Submission of Further Information (FI)

**Temporary Animal Boarding Establishment with Ancillary Facilities and associated
Filling of Land for a period of 5 years in "Agriculture" Zone,
Lot Nos. 1493 (Part) and 1500 (Part) in D. D. 107 and Adjoining
Government Land, Yuen Long, New Territories
(Application No. A/YL-KTN/1177)**

Further Information for Planning Application No. A/YL-KTN/1177**Response-to-Comments****Comments from Drainage Services Department**

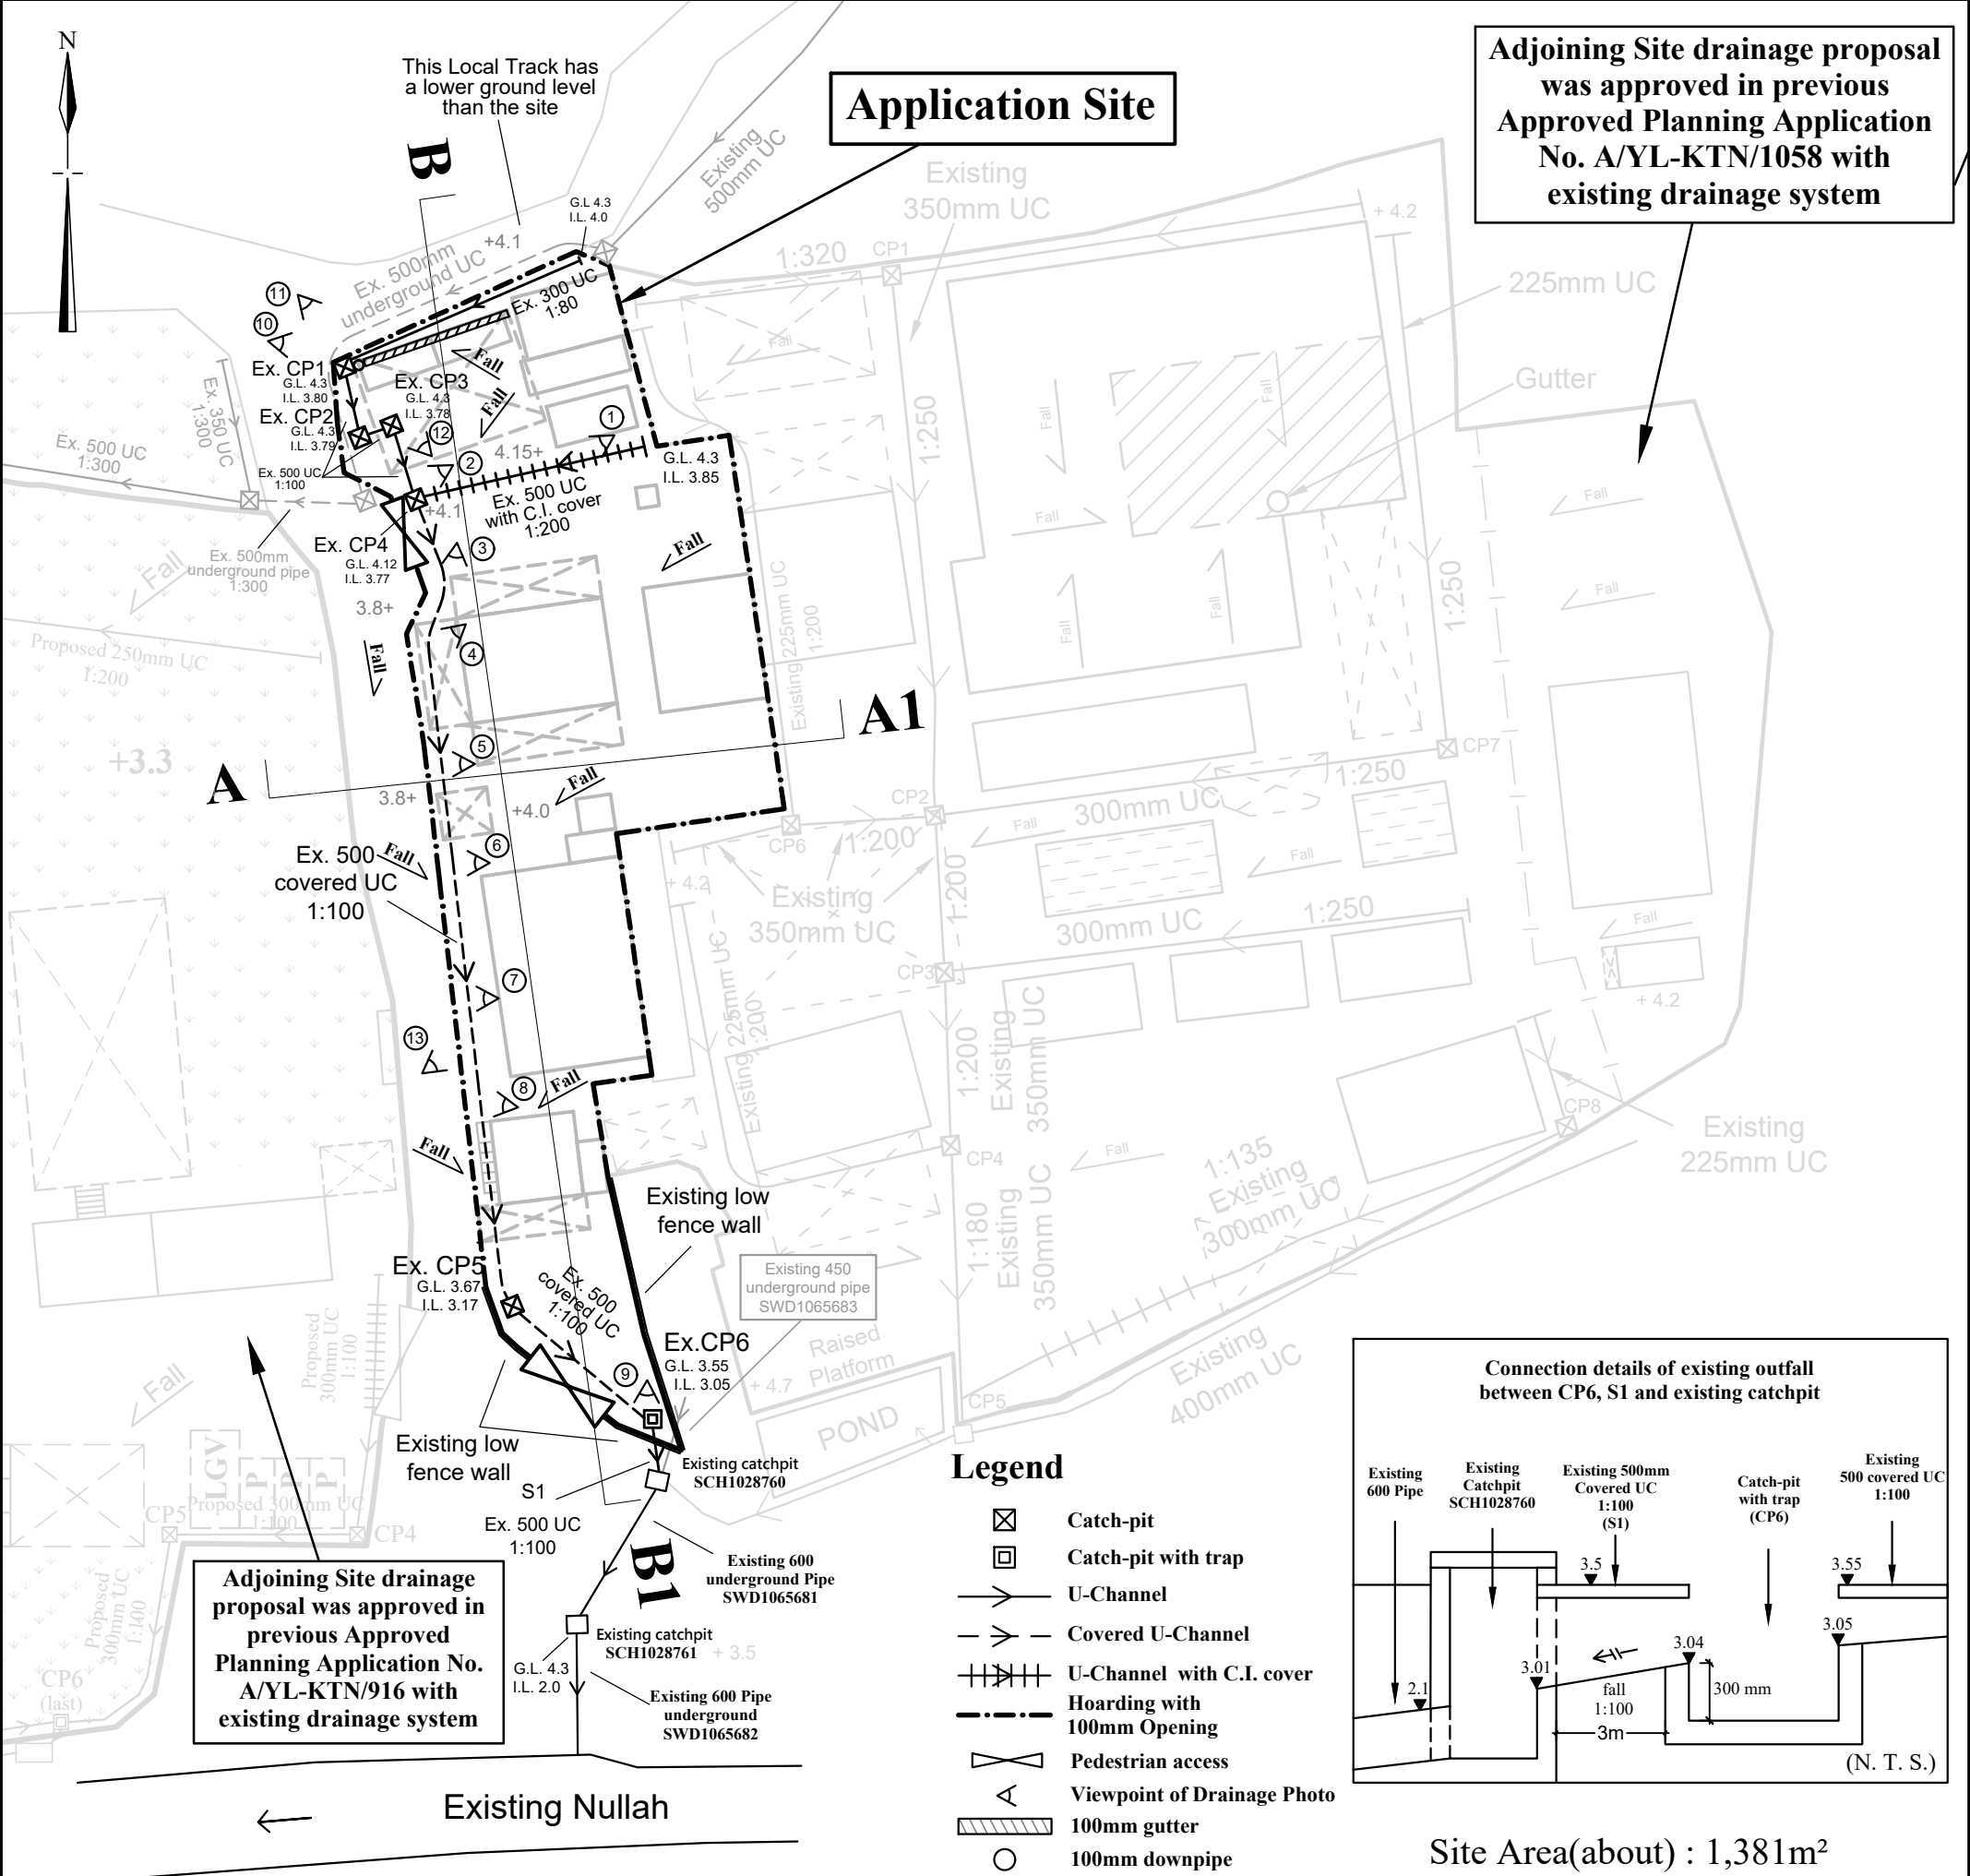
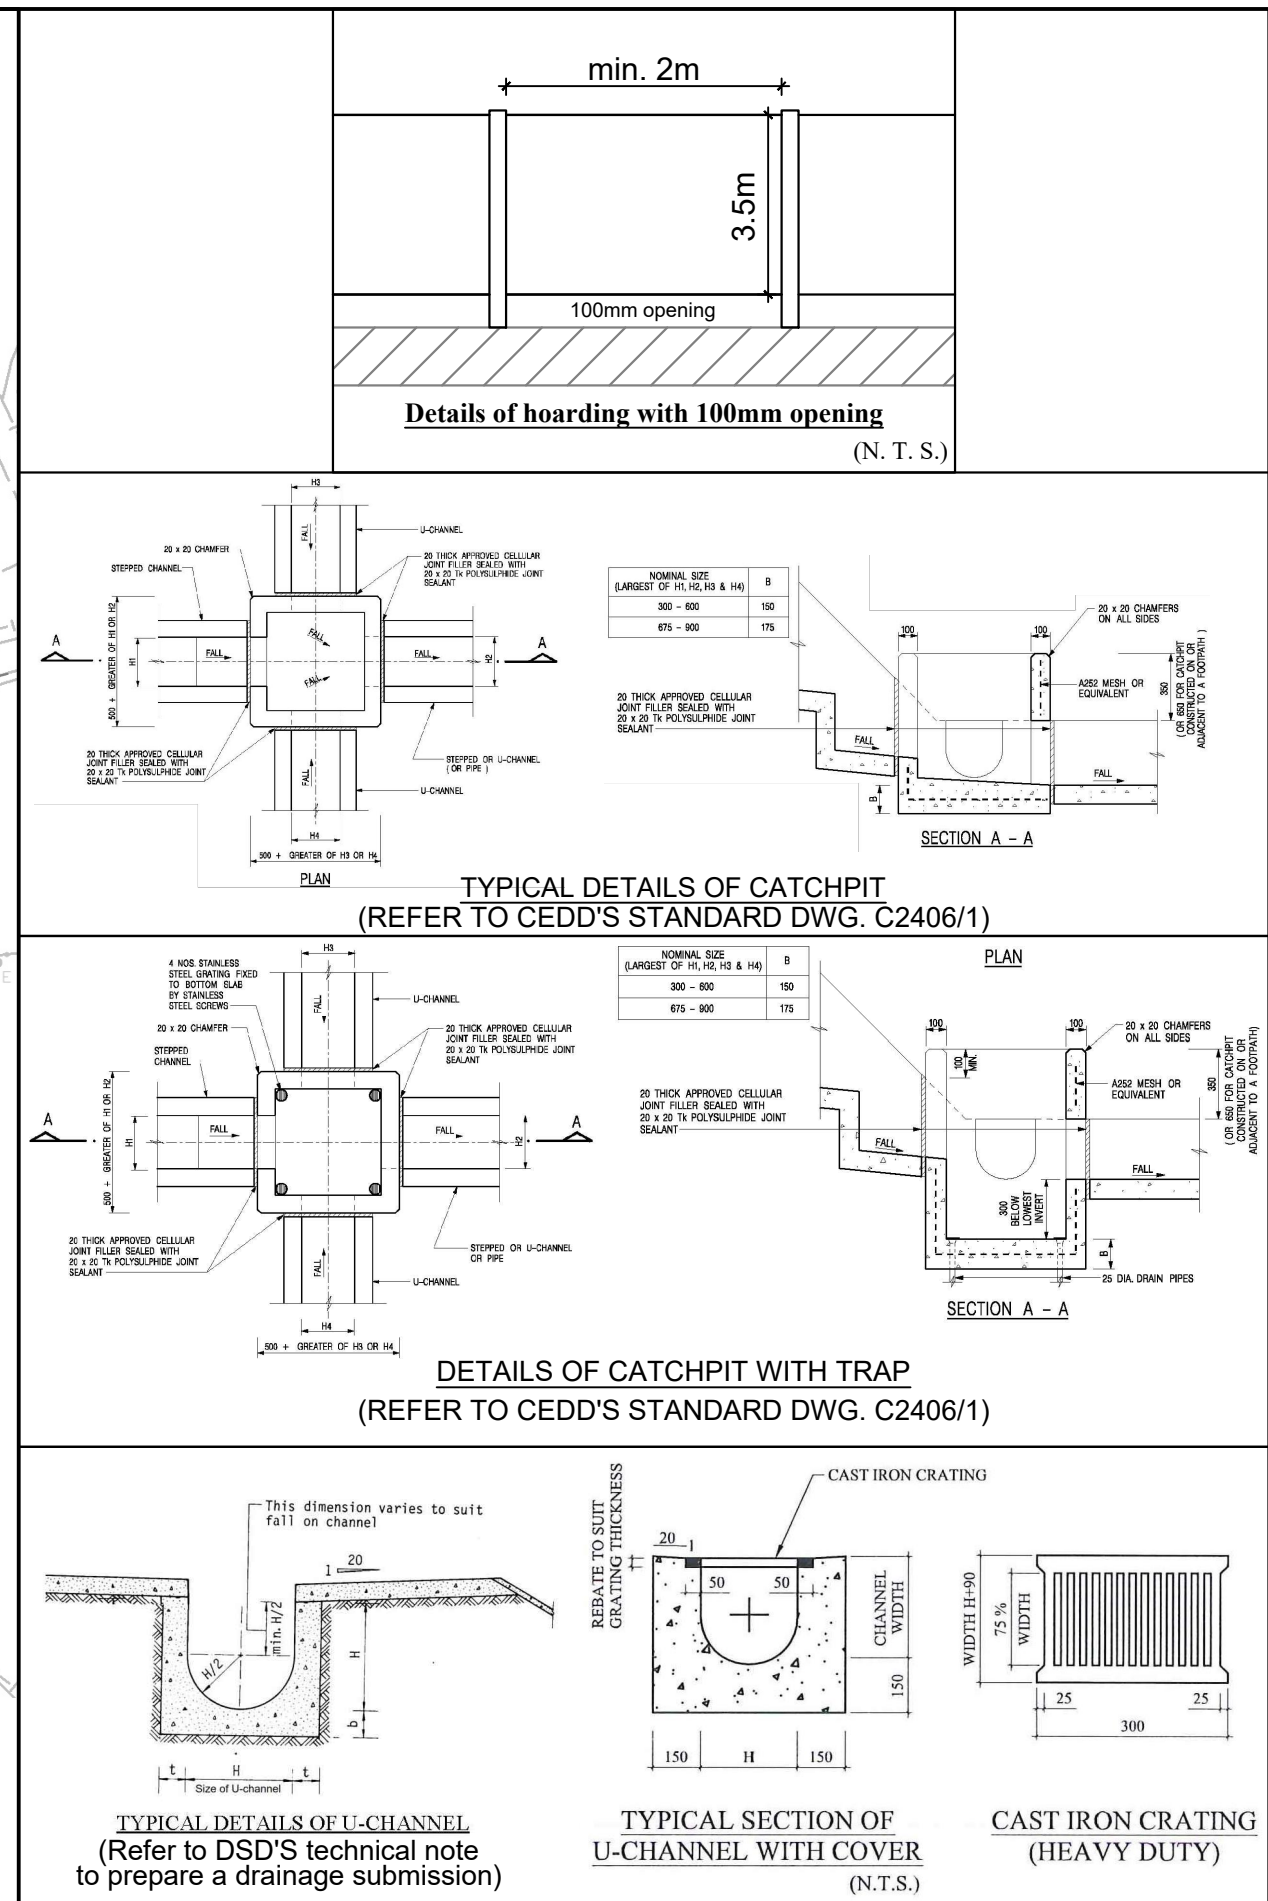
I.	Comments	Responses
1.	Sections - Please indicate the hoarding opening in drawings.	Hoarding with opening is provided at the western side of the site. Please refer to updated Drainage Proposal (Plan 6.1b) for details.
2.	Section B - Please review the adjacent site ground levels. According to our record, the adjacent road level is higher than the application site, external catchment area should be considered. Please update the section and calculations if necessary.	Portion of the adjacent road at the west is at a higher level than the site. External catchment area is included. Please refer to updated Drainage Proposal (Plan 6.1b and Plan 6.2b) and Hydraulic Calculations for details.
